## REMARKS

III. The rejection based on newly cited Nagashima et al., U.S. 5,742,735.

Fig. 1

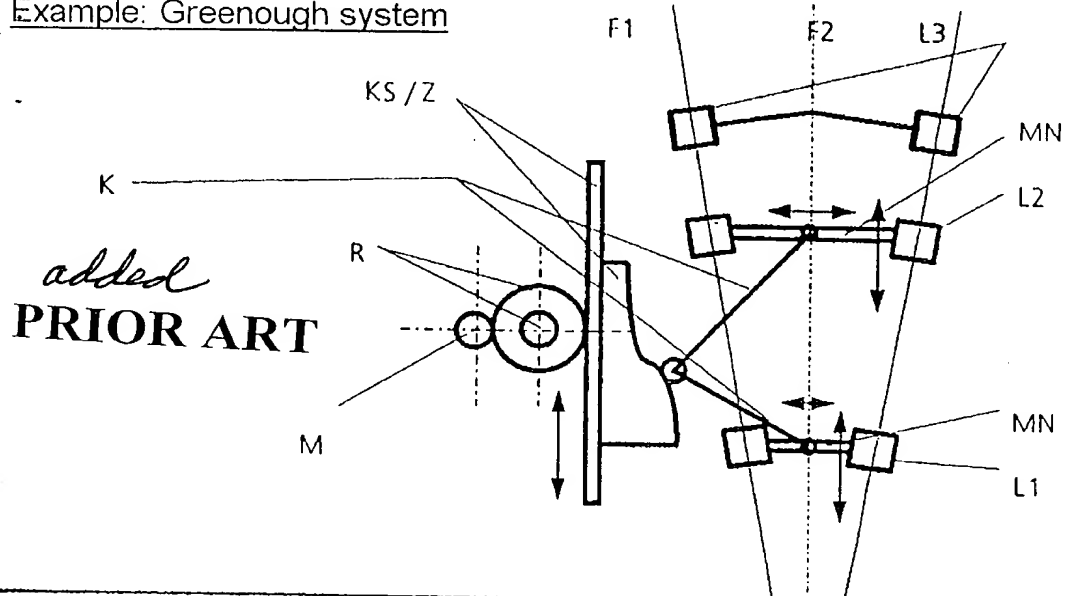
I. The drawing correction is submitted in the new format "replacement sheet" attached to the back of this amendment.

The words "PRIOR ART" have been added.
